# **Final Supplemental Environmental Impact Report**

***Volume 8***  
***Chapter 7 – Responses to Comments***

**Golden Queen Mining Co. Inc., Soledad Mountain Project**

**RE: Supplemental Environmental Impact Report - Response to Comments - Revised Soledad Mountain Project by Golden Queen Mining Co., Inc. (PP08210)**

## GENERAL SITE LAYOUT

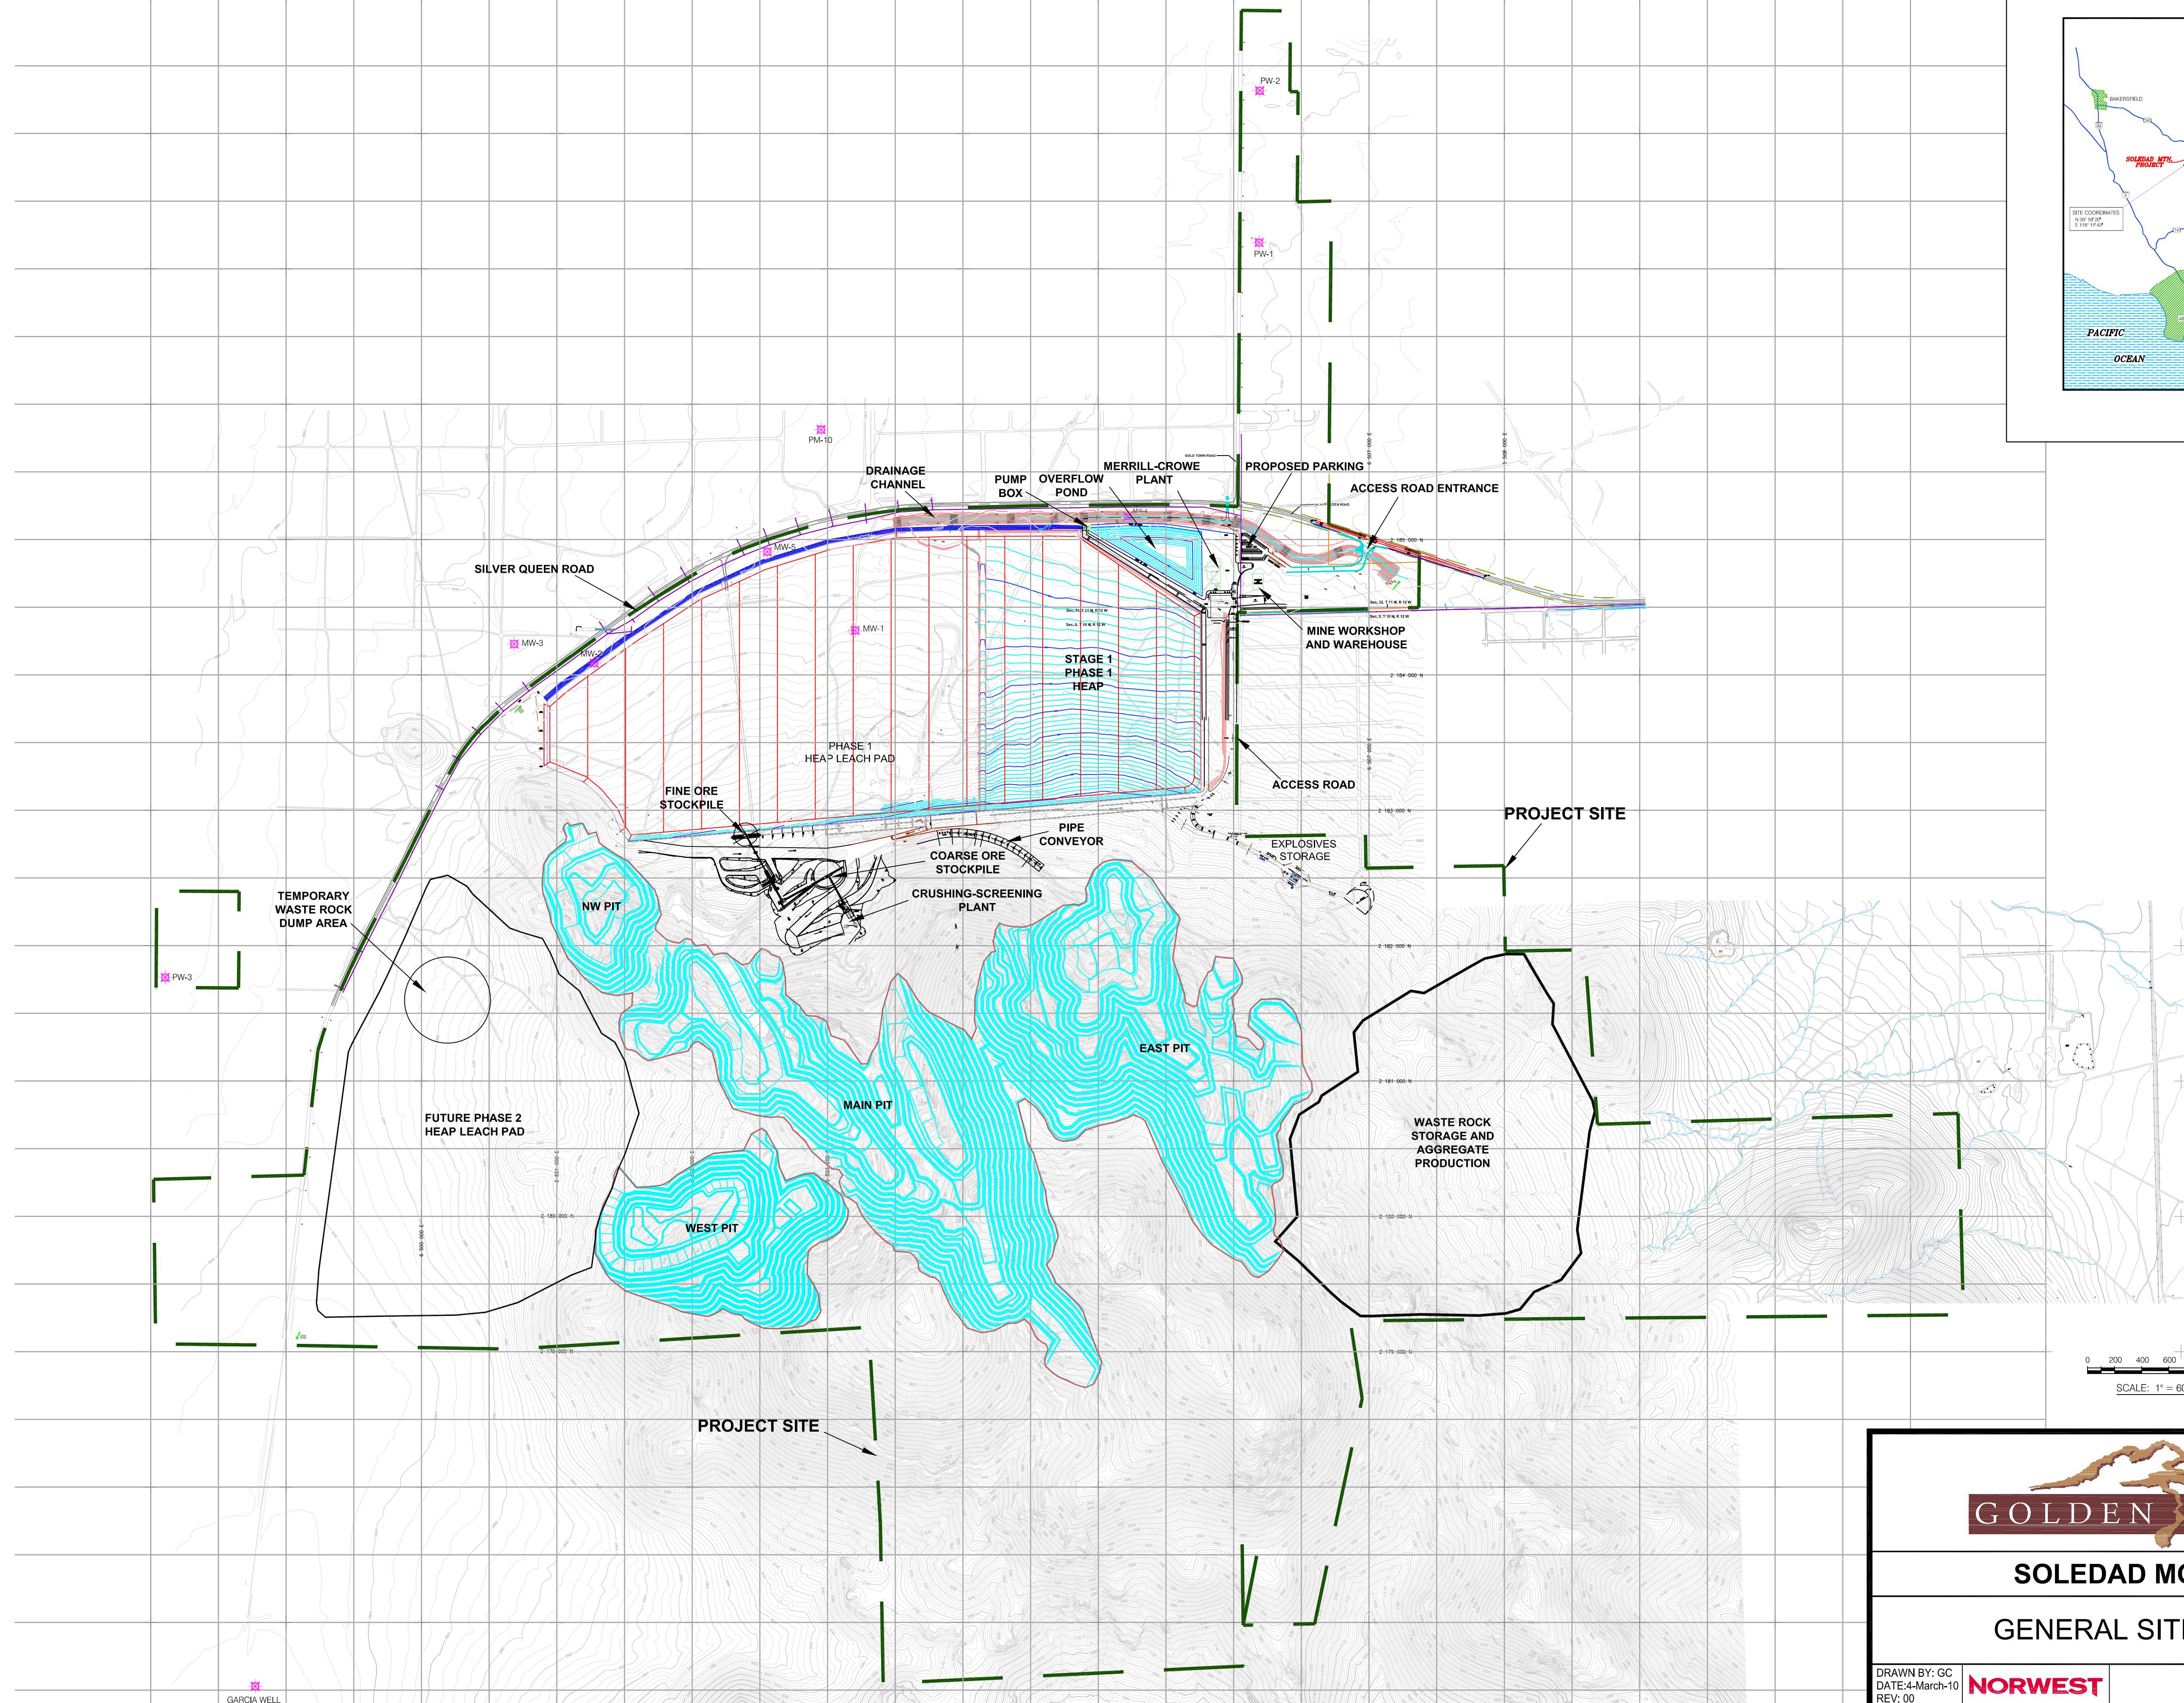
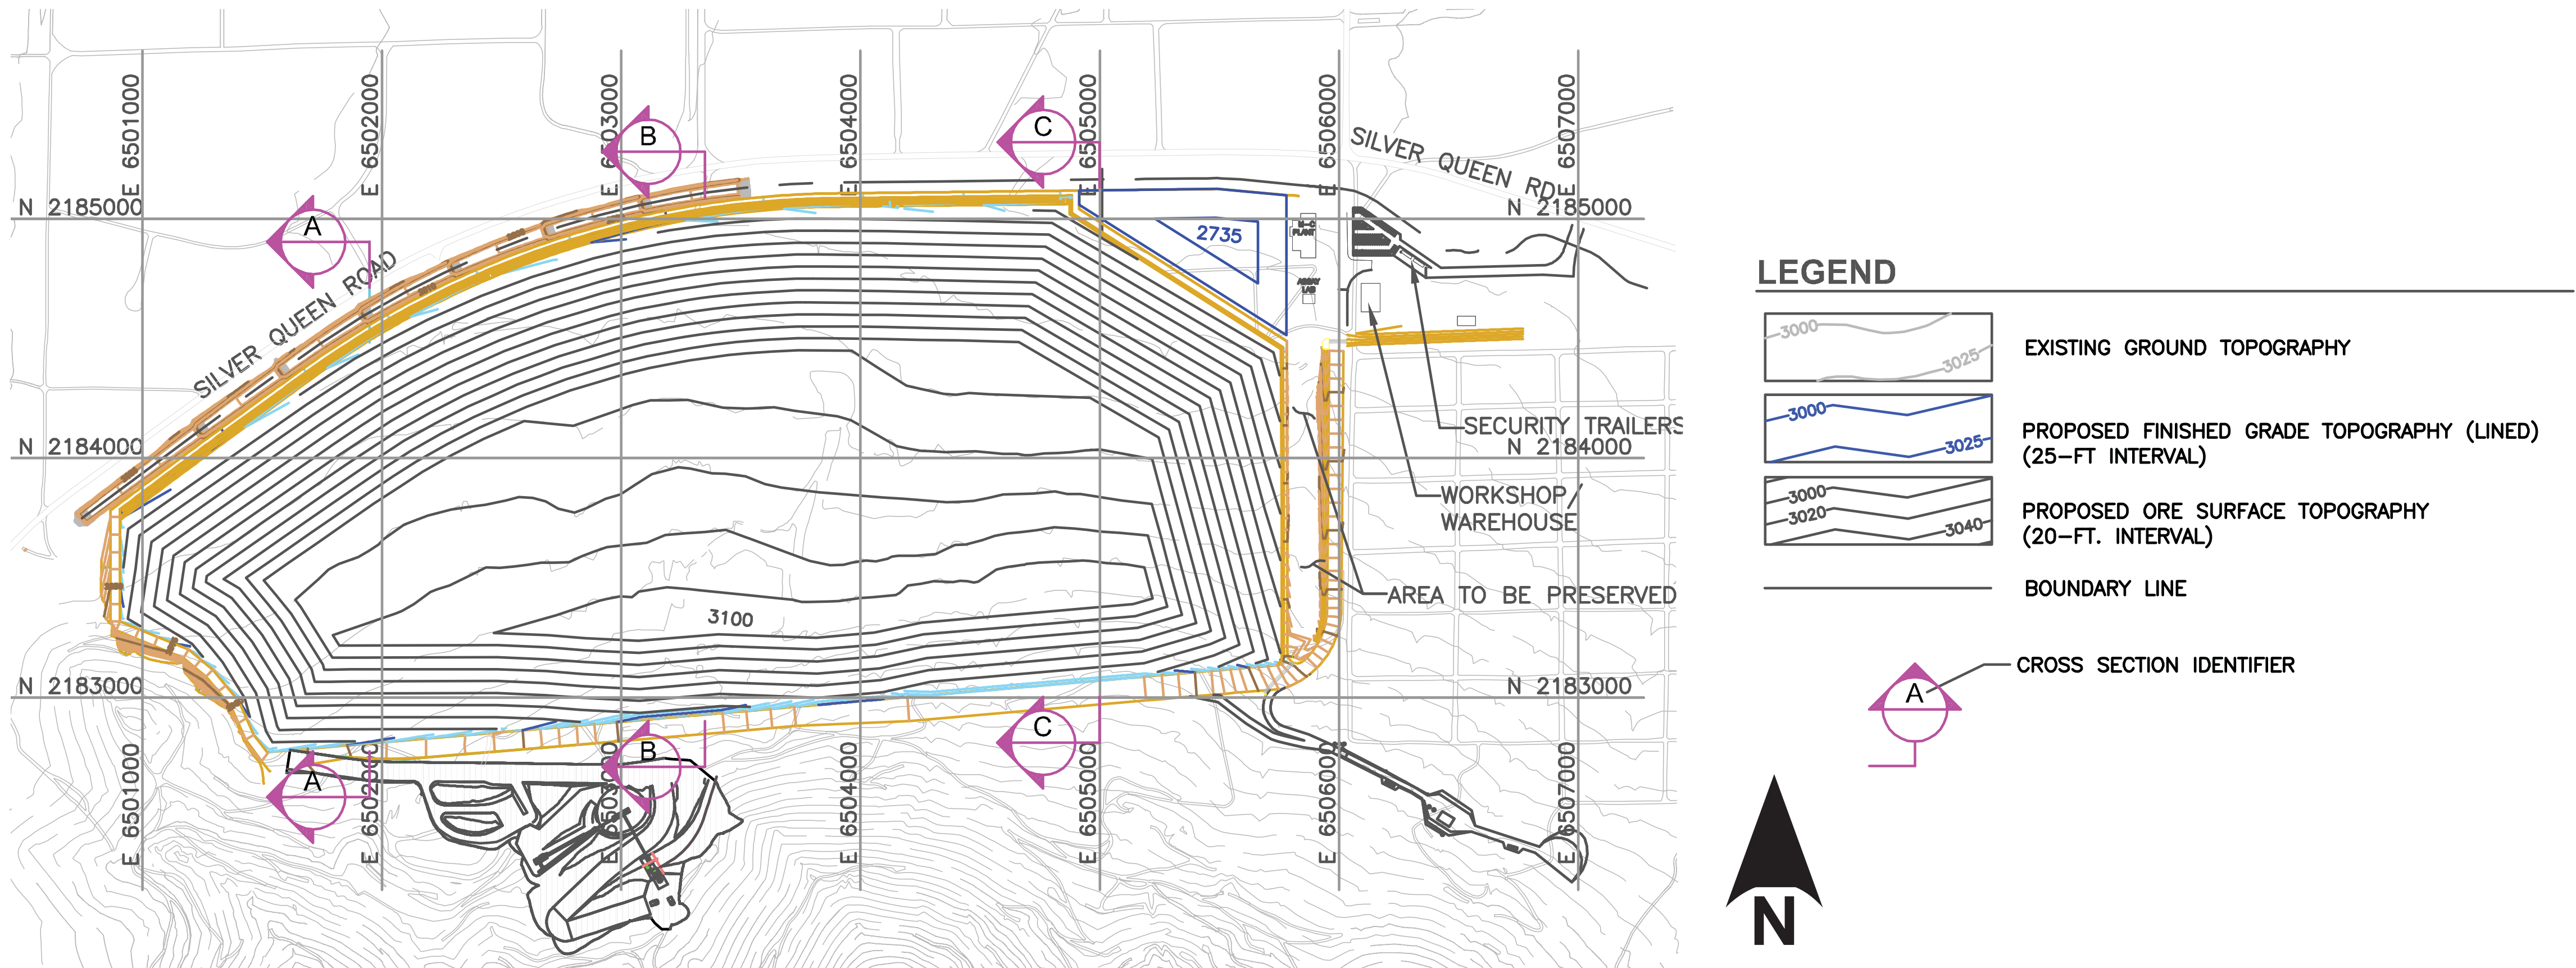
- Figure 3-12 General Site Layout (SEIR)

Figure 3-14  
Heap Leach Pad Design

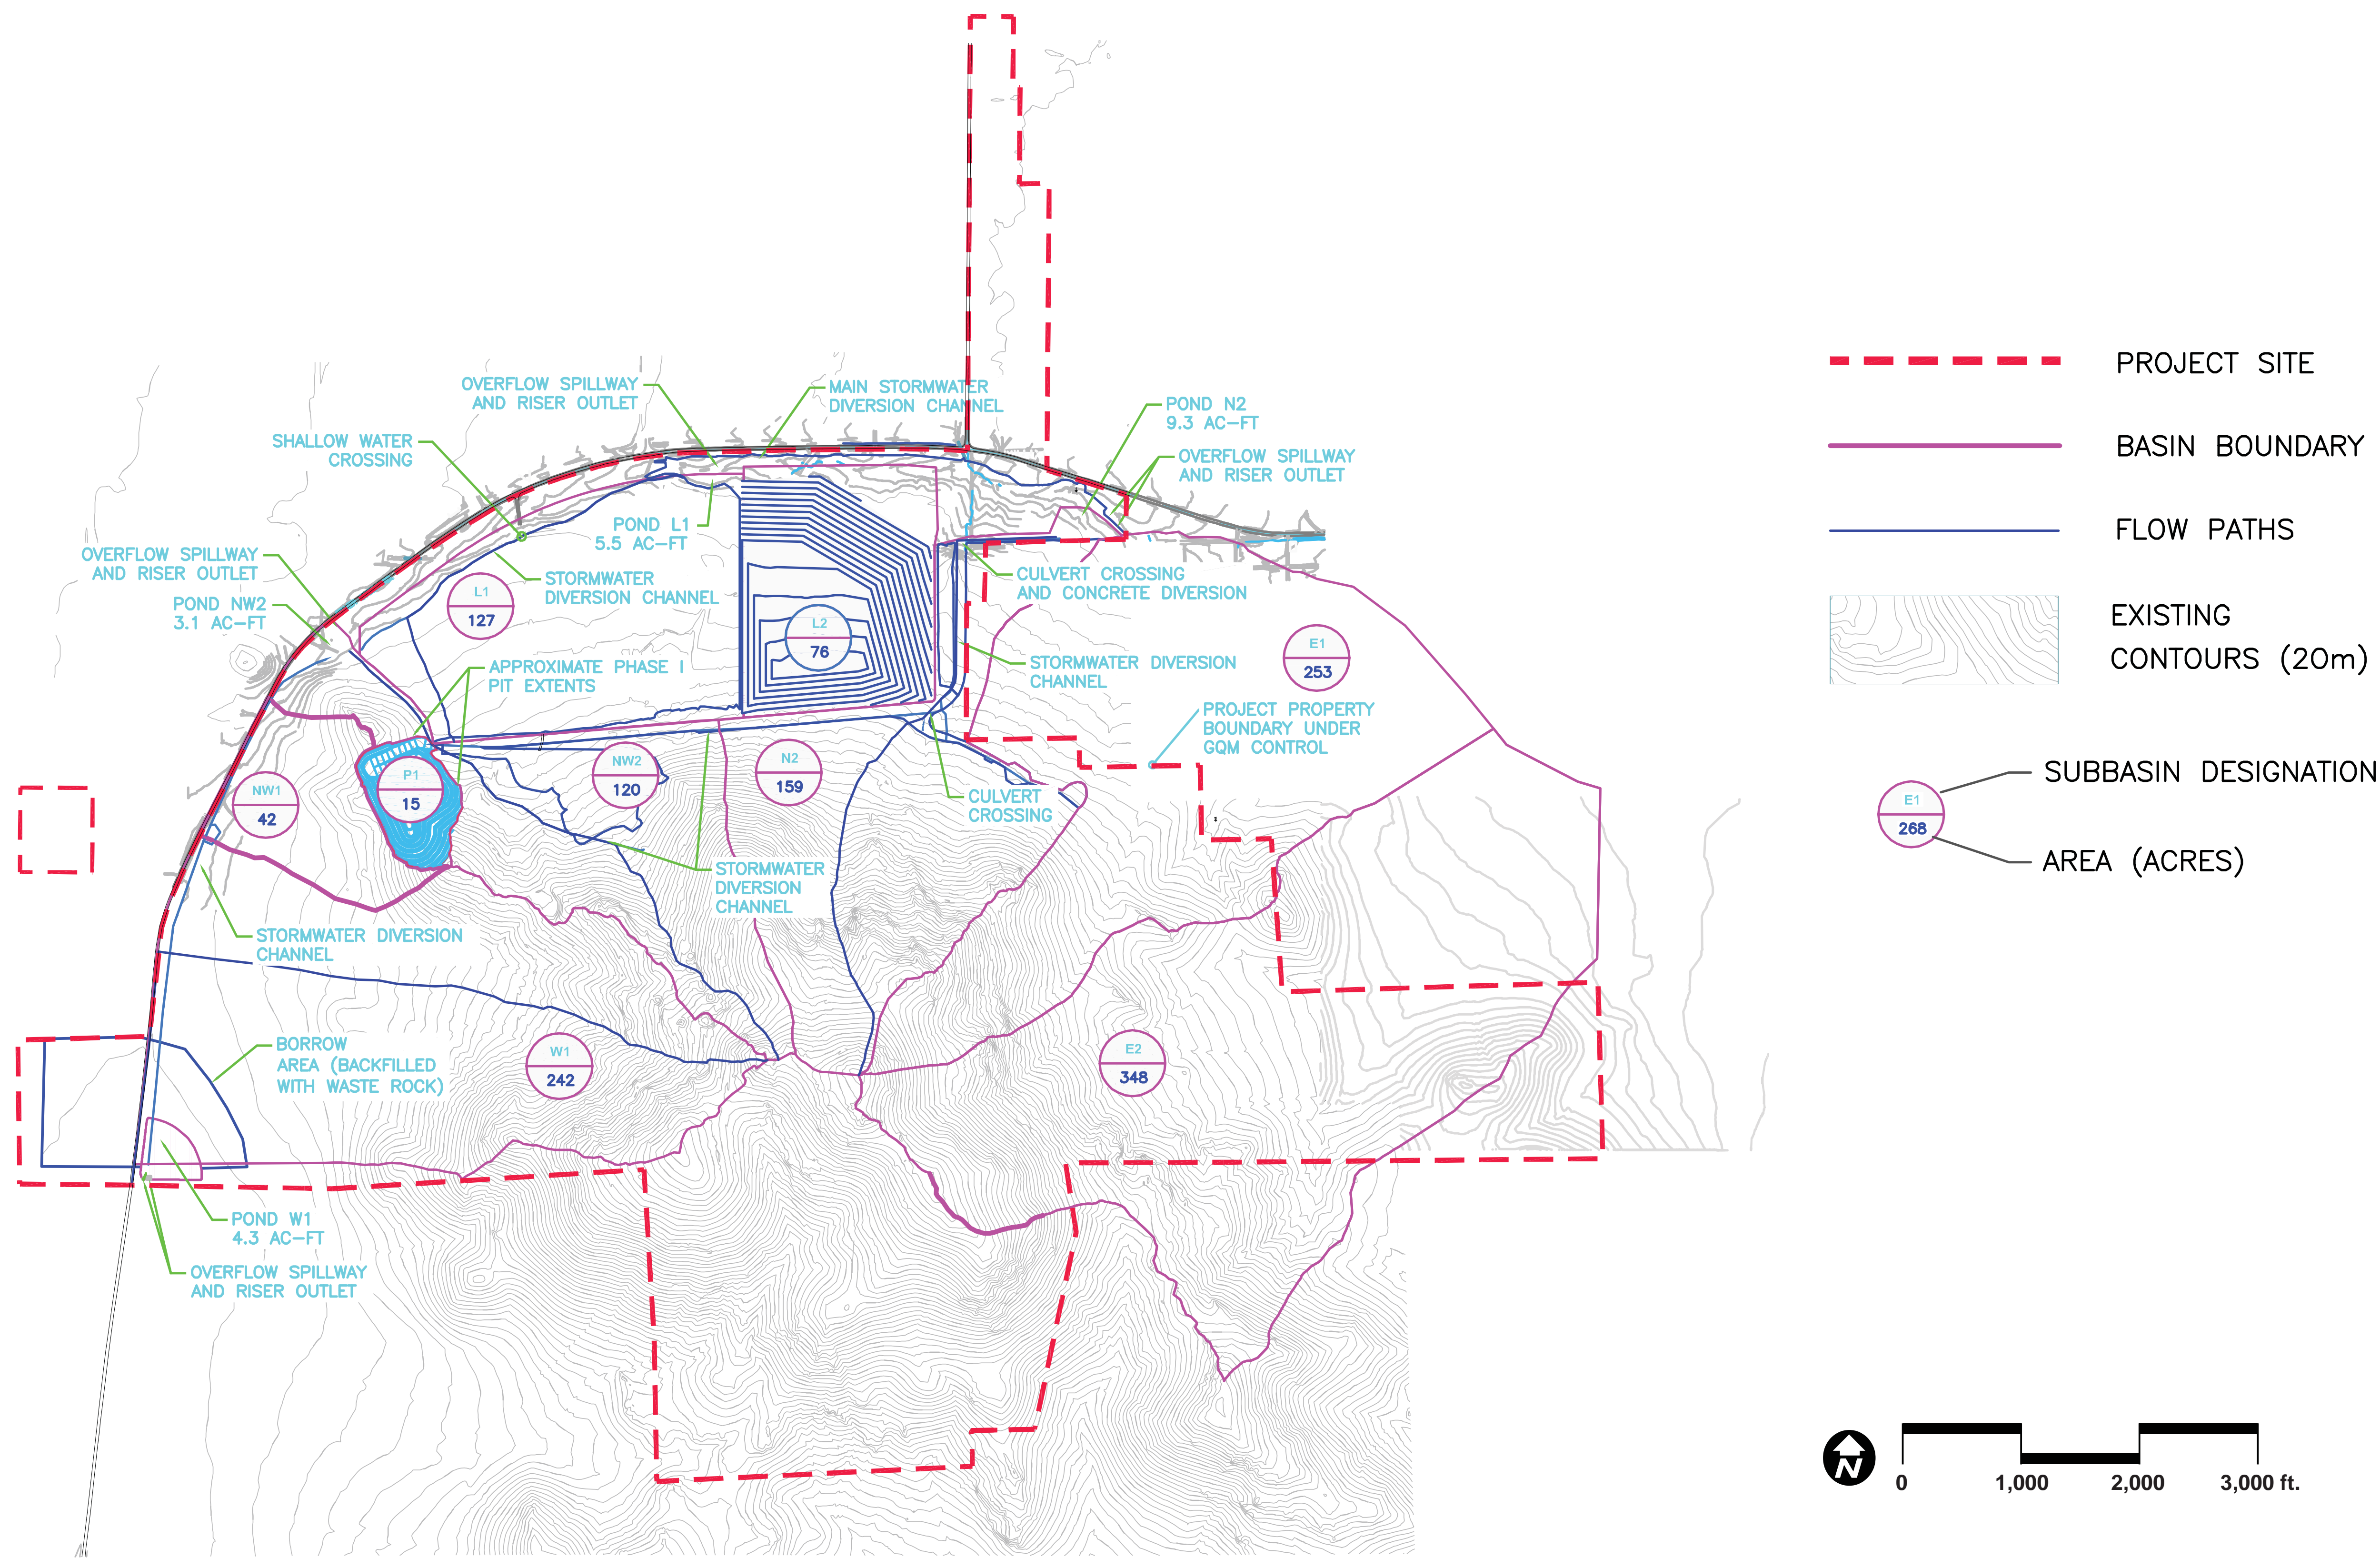
- All figures should have thorough explanations and show information referenced in the text of the document. For example:
    - Figure 3-15, *Stage 1 Channel Construction Plan*, shows existing contours in the explanation but they are illegible on the map. Additionally, a set of contours in the general location of the proposed heap leach pad are not referenced in the explanation or labeled on the map.
